**CALIFORNIA REGIONAL WATER QUALITY CONTROL BOARD  
SAN DIEGO REGION**

**FACT SHEET  
TENTATIVE ORDER NO. 2001-283  
NPDES PERMIT NO. CA0001368**

**WASTE DISCHARGE REQUIREMENTS  
DUKE ENERGY SOUTH BAY, LLC  
SOUTH BAY POWER PLANT  
SAN DIEGO COUNTY**

Discharge Channel of the South Bay Power Plant

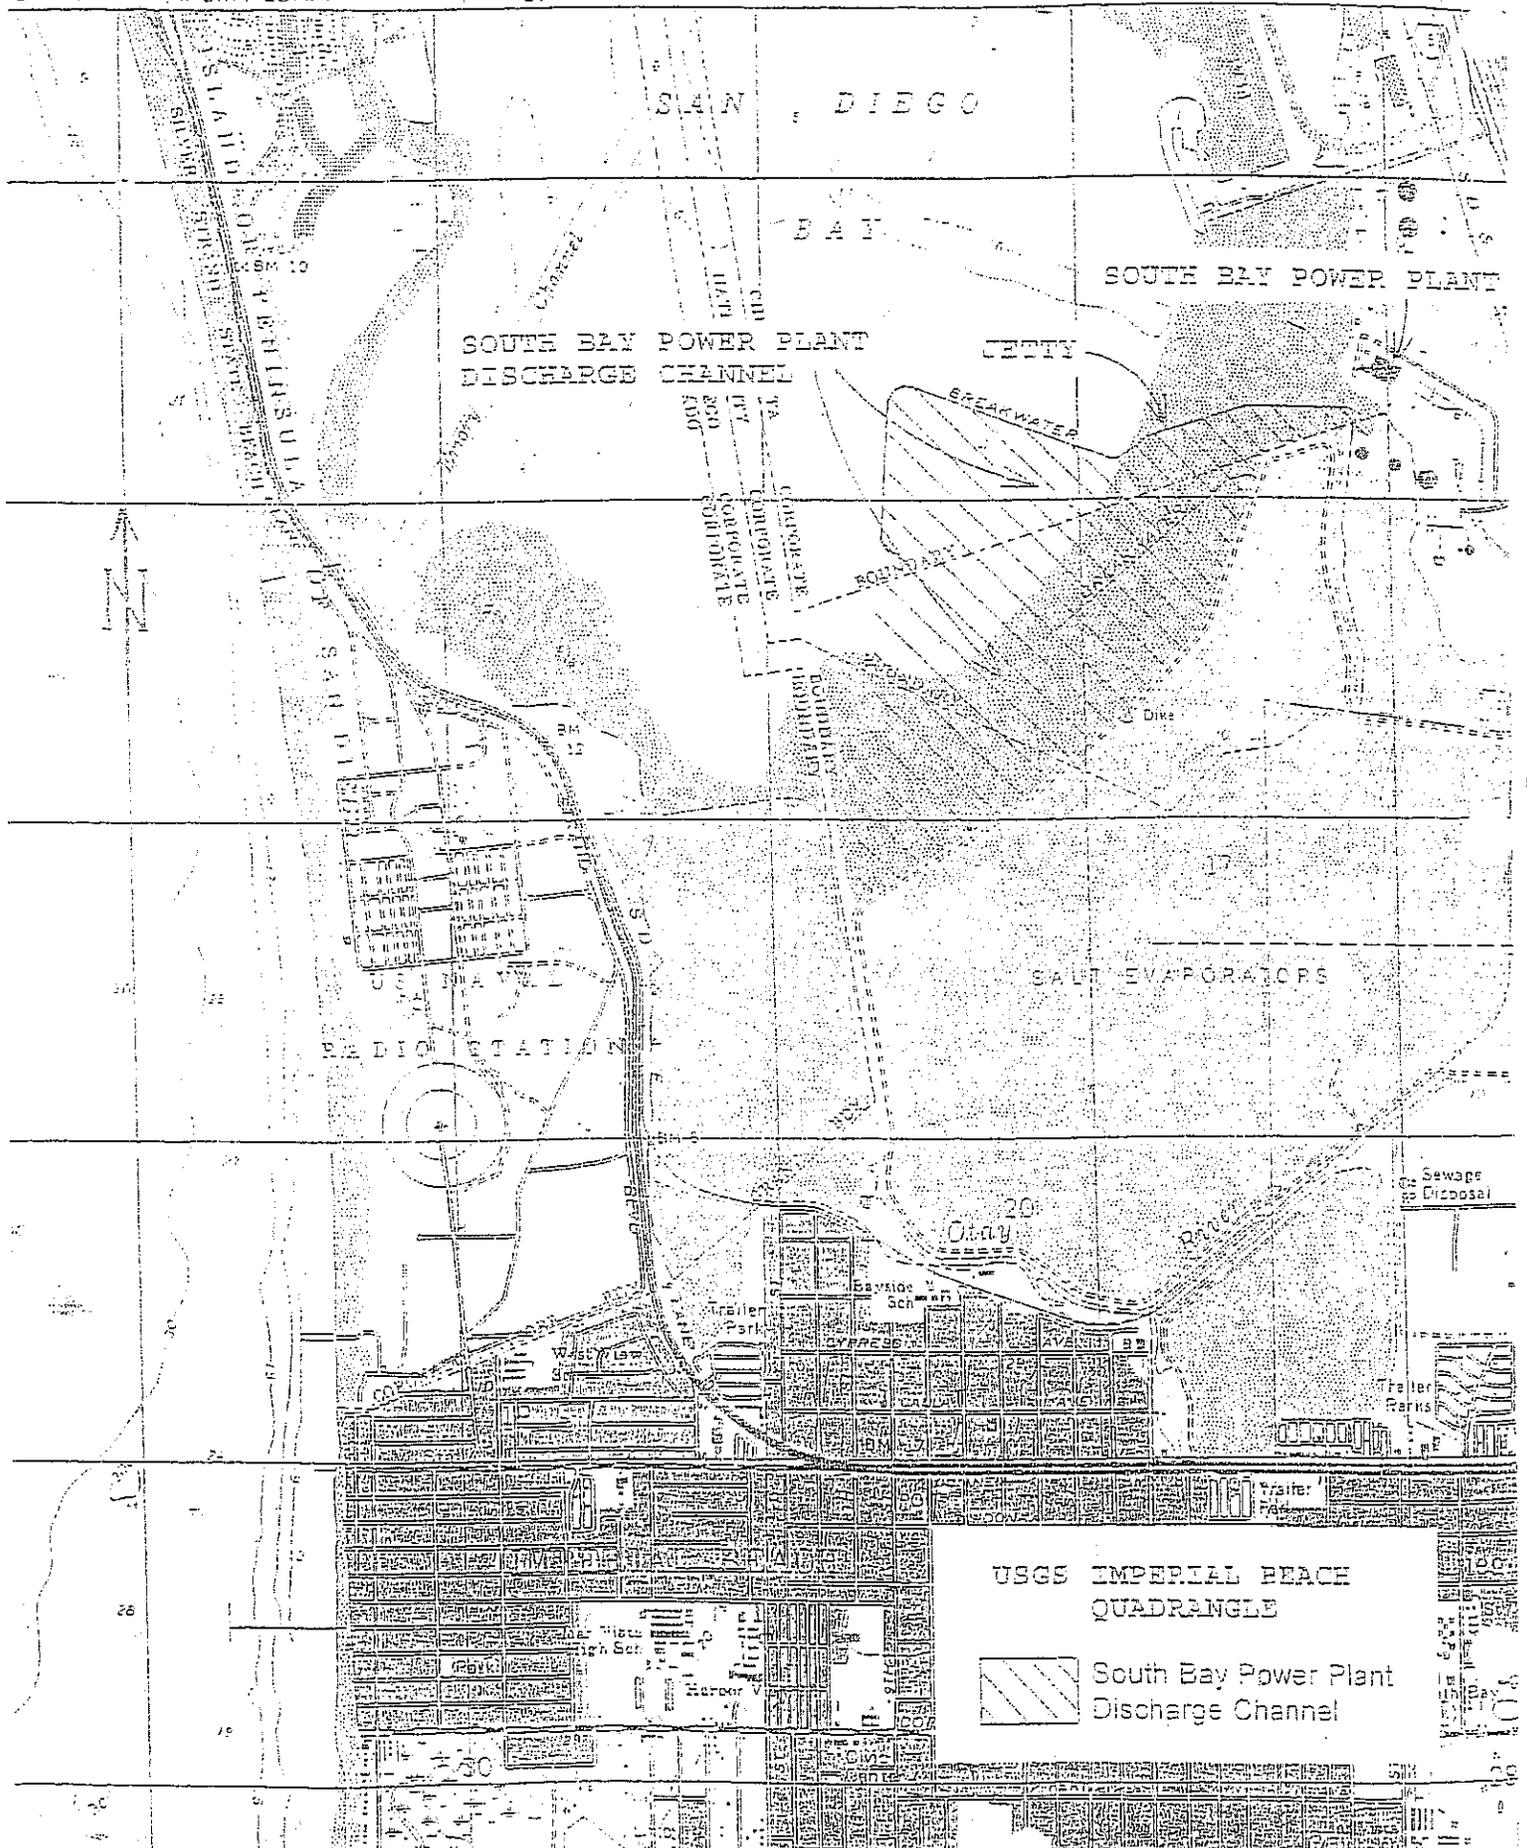
*\* Where is the legal jurisdiction for this depth of the d. channel. This is water for a...  
\* If we allow this change here to find dry core when new plants build*
